23rd December 2020

PART 8 Public Consultation – Response

Pedestrian and Cycle Route from Ballinacurra to Midleton

Fig. 2- Note the Blue route running parallel to the train line which is outlined to be a secondary cycling route on the Cork Cycle Network Plan.

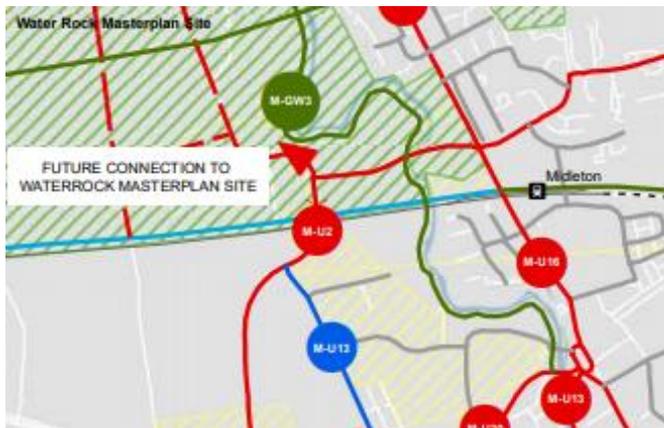
- The Greenway should branch off after the proposed underpass and run parallel to the train line (via a cyclist and pedestrian bridge over the tributary) joining up to the start Midleton-Youghal Greenway at the train station. This section of the greenway would form part of the the proposed secondary cycling route running parallel to the train line between Midleton and Carrigtwohill as outlined in the Cycle Network Plan (blue route in Fig. 2).
